STAFF REPORT

Urban Downs PH 2: Preliminary PUD, Critical Areas, SEPA with Archaeological Predetermination

File No. MASTER-22-0015, PLZ-22-0024-0027

Figure 2: Urban Downs PH 2 Proposed Plat

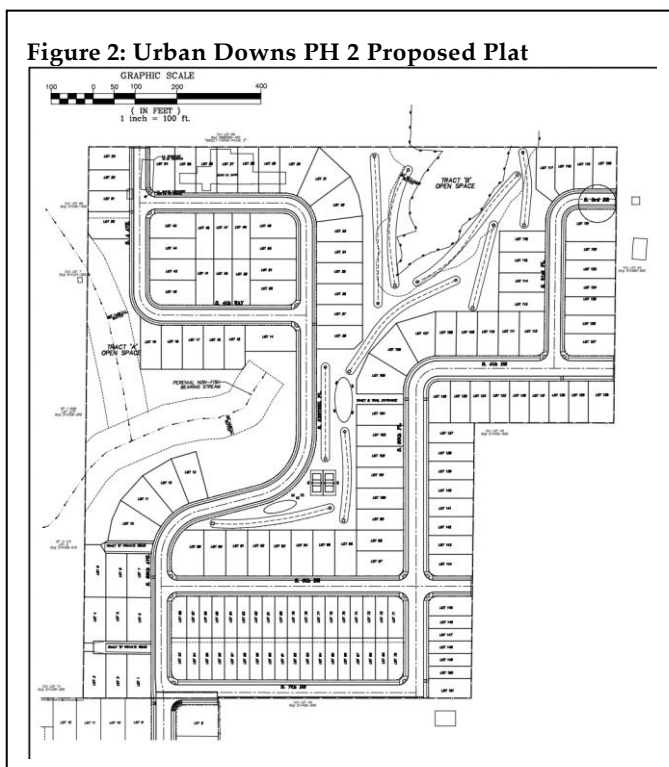
As a **condition of approval**, prior to final plat approval, the applicant shall demonstrate that lots 20, 21, 22 and 23 in the north corner of Urban Downs PH2 comply with the perimeter compatibility standards in RDC 18.401.080.C.3.a – c.

As a **condition of approval**, prior to final plat approval, the applicant shall modify the plat to ensure all detached unit lots meet the minimum thirty-five foot lot frontage requirement in RDC 18.401.010.I.1.

detached unit lots, not on a bulb of a cul-de-sac, do not meet the minimum thirty-five (35) foot frontage. The lots with substandard frontage are lots 10, 13, 33, 105, 117, and 118. Lot 119 is a flag lot. The 41 proposed townhouse all have lot frontage greater than 25 feet. As a **condition of approval**, prior to final plat approval, the applicant shall modify the plat to ensure all detached unit lots, other than flag lots, meet the minimum thirty-five foot lot frontage requirement in RDC 18.401.010.I.1.

1. The development shall contribute transportation impact fees toward citywide impacts.
2. The development shall dedicate right-of-way and construct a new local street stub to the site’s west boundary roughly between lots 4, 5, and 6 and lots 7, 8, and 9. This street will allow for future local street connectivity. The stub street shall comply with the City’s intersection spacing standards along S 88th Avenue.
3. The development shall provide secondary access for emergency vehicles through a public street connection, private street connection or an easement.
4. Signing shall be placed at all street stubs within the development to communicate the planned future extension of the roadways.
5. Minimum sight distance requirements shall be met at all site driveways. Sight distances should be re-verified in the final engineering/construction stages of development.
